12th Meeting of the IHO (S-100WG) S-101 Project Team

Covered Structures Over Navigable Water

Agenda Item 06.9

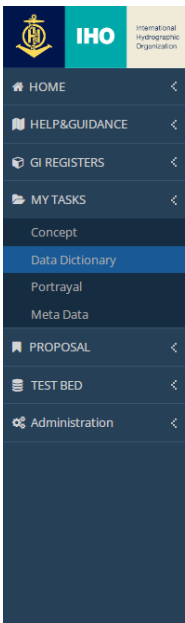
Management Details			
Proposal Type	Addition	Submitting Org	IENC
Successor	--	Date Proposed	2023-06-05
Predecessor	--	Date Accepted	
Proposed Change	Add a new enumeration value		
Justification	There are several examples of roofs and buildings over the navigable waterway. It is important to be able to encode such a construction accurately.

- **Response from Registry Manager:**

My rationale for considering these as an obstruction is that if the vessel dimensions exceed any of the vertical or horizontal clearance restrictions for the structure over the water then (not to mention the existence of any supporting infrastructure such as stanchions or pylons) the structure is definitely an obstruction for that vessel in what would be considered otherwise navigable water.

However, thinking about this in regard to your comments, I think the best option moving forward, taking the example of the modelling of a separate feature class for bridges, would be to consider a new feature class such as `StructureOverNavigableWater`, which could, for example, contain an attribute `categoryOfStructure` to further define the type/purpose of the structure. The other attributes for this feature could be based on the attributes for the `Bridge` feature (vertical and horizontal clearance, height and length, colour, `natureOfConstruction`, `visualProminence`, `radarConspicuous`, ...) + `maximumPermittedDraught`, minimum depth, and possibly an indication of the intended vessel type. The `categoryOfStructure` could contain values such as `boathouse`, `coveredBerth`, `maintenanceShed` etc. My thinking on this is also informed by the requirement for ECDIS functionality/performance (display category, viewing group, alarms and indications, ...) which I think would be simplified by the inclusion of a new feature class rather than trying to extend an existing class. Consideration also needs to be given to introducing new attribution to an existing feature class that are unique to a relatively uncommon real-world circumstance for a relatively generic concept (such as building). Recent discussions in the S-101PT resulted in the removal of mooring buoy as a value for the attribute `categoryOfMooringWarpingFacility` as this required the inclusion of the attribute `buoyShape` on the feature `MooringWarpingFacility` which is only required if the feature is a mooring buoy - it has been decided that mooring buoy will be re-modelled as its own feature class.

- IEHG, on consultation, have agreed in principle with this proposal.
